Product Change Notice (PCN)

PCN Number: **PCN-0451213R-01**

Product(s) Affected: **PJ-059BH**

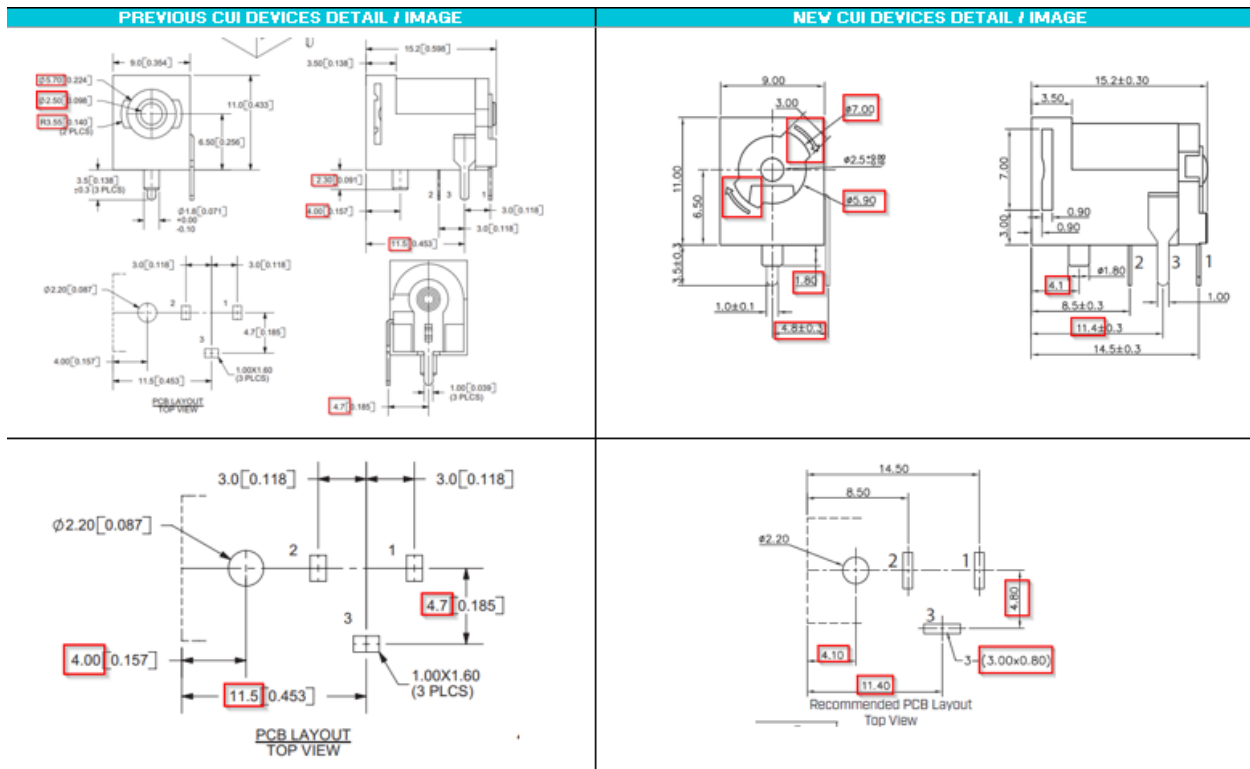
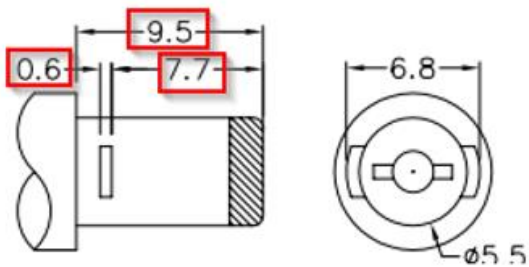
Description of Change: **Minor Housing and footprint differences. Material Change on the housing and terminals. See image Below**

PREVIOUS CUI DEVICES DETAIL / IMAGE			NEW CUI DEVICES DETAIL / IMAGE		
	MATERIAL	PLATING	DESCRIPTION	MATERIAL	PLATING/COLOR
center pin	copper	nickel	center pin	brass	nickel
terminal 1	brass	silver	terminal 1	brass t=0.30	silver
terminal 2	copper alloy	silver	terminal 2	bronze t=0.25	silver
terminal 3	brass	silver	terminal 3	brass t=0.30	silver
plastic	PBT		cover	PBT (UL94V-0)	black
			housing	PBT (UL94V-0)	black

MATING PLUG
Jack Insertion Depth: 9.8 mm

MATING PLUG
Jack Insertion Depth: 9.5 mm
